PARTS & SERVICE NEWS

REF NO.	AT02029
DATE	Mar. 8, 2002

SUBJECT: MODIFICATION PROCEDURE OF TORQUE CONVERTER PUMP HOSE FAILURE ON WA800/900-3.

PURPOSE: To introduce modification procedure to prevent occurrence of breakage failure of the outlet circuit hoses and tubes from the torque converter pump on WA800-3, WA900-3 and WD900 wheel loaders

1. Introduction

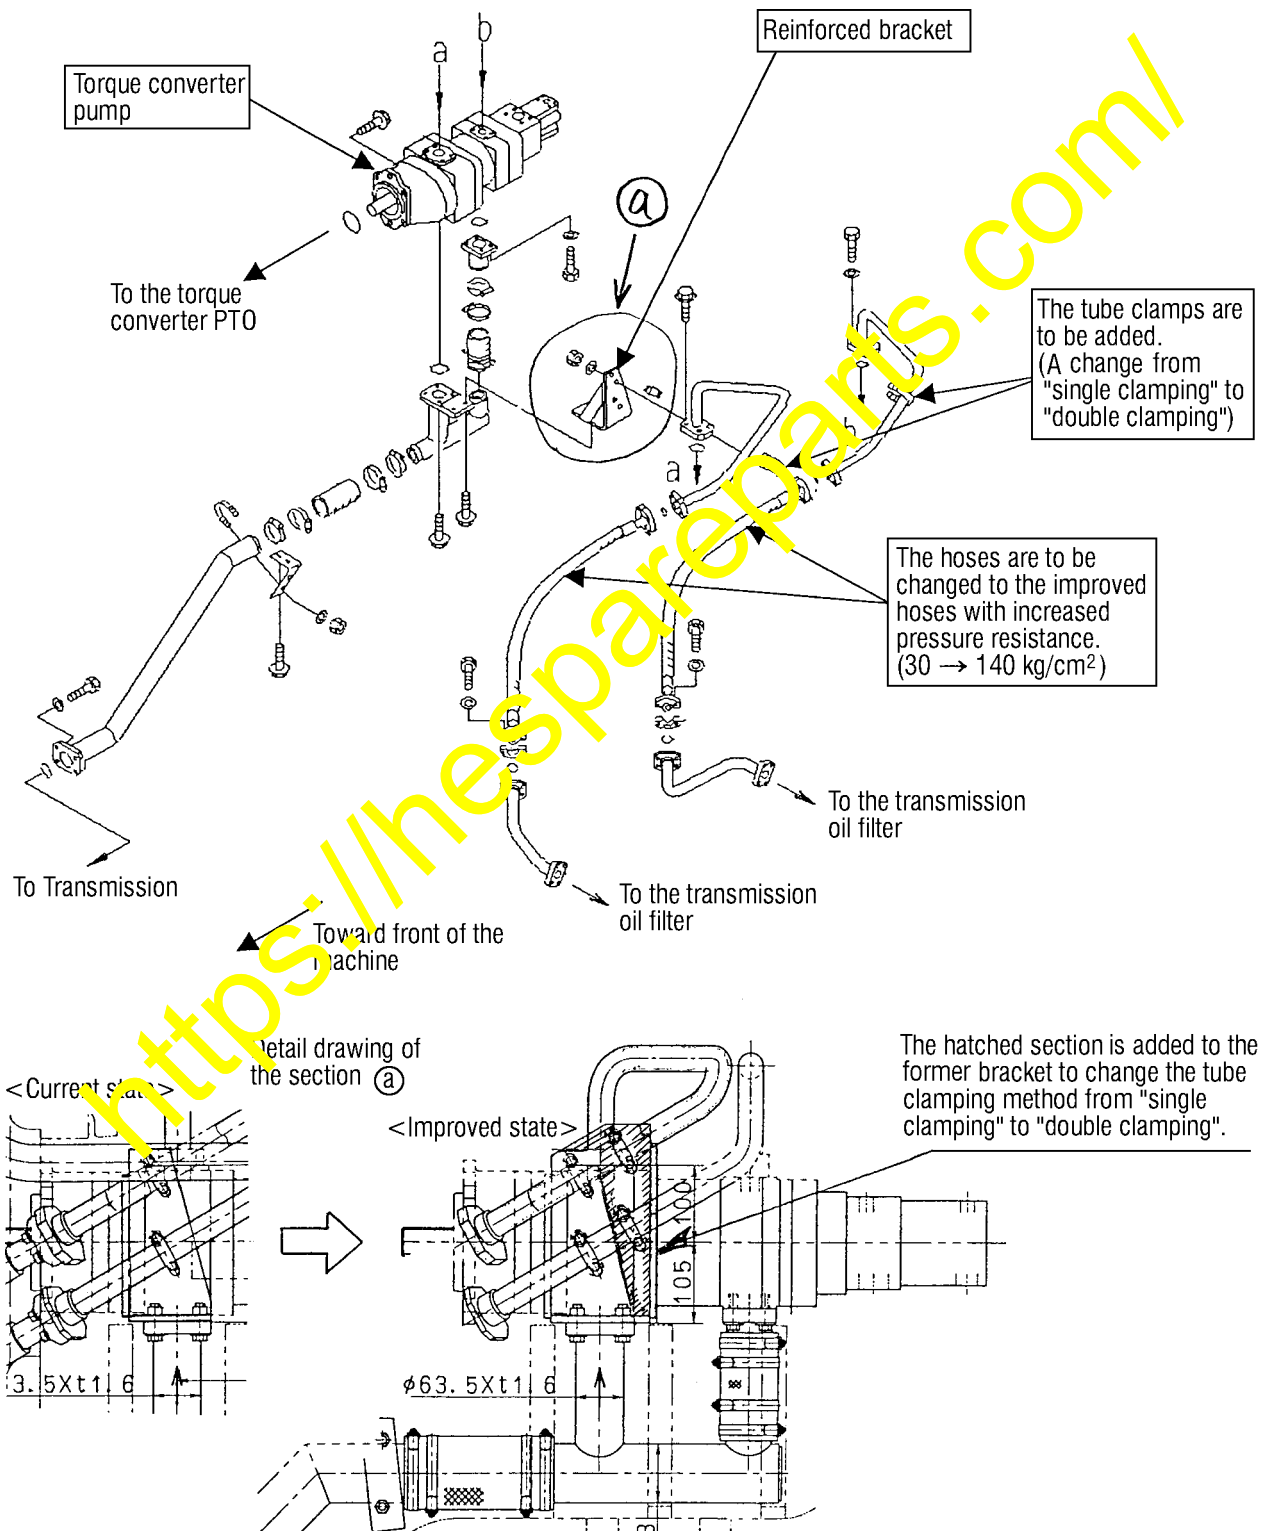
By pulsations, etc. of the discharge pressure from the torque converter pump on the WA800-3, WA900-3 and WD900 wheel loaders while the oil temperature is still low, breakage failure may occur with the outlet circuit tubes and hoses. Therefore, implement the modification following the procedures being outlined in this Service News to prevent occurrence of the above failure.

② Adding the tube clamps.

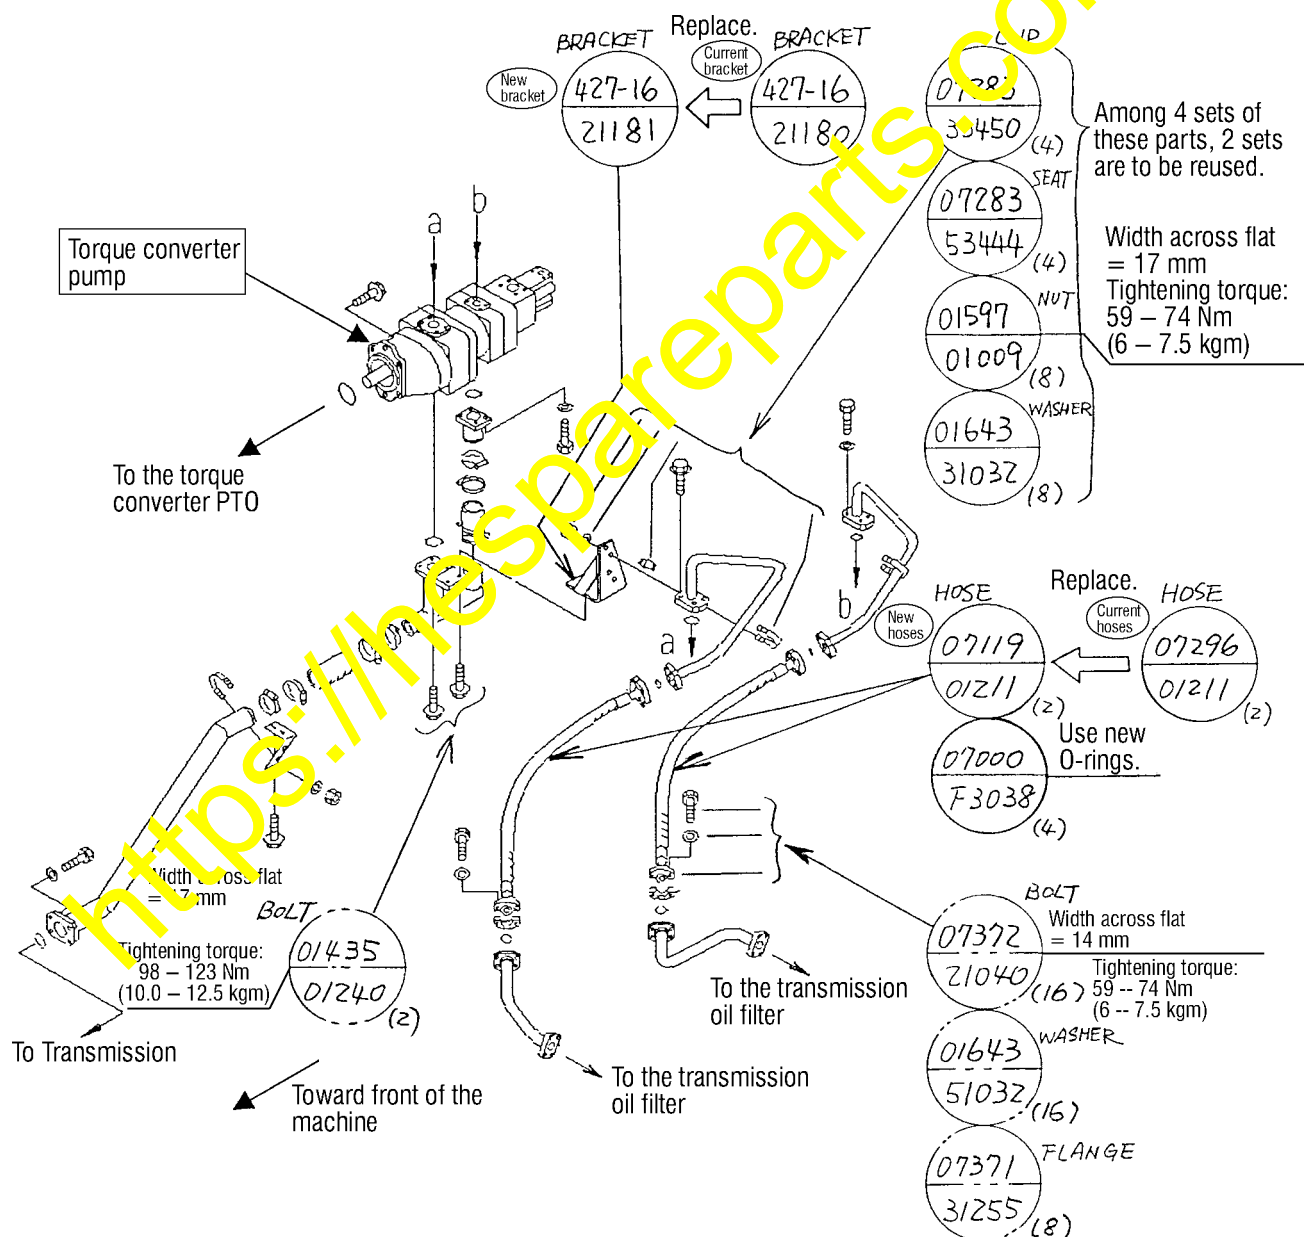
Change the current single clamping method to the double clamping method.

(There are mounting holes for the additional clamps on the reinforced new bracket.)
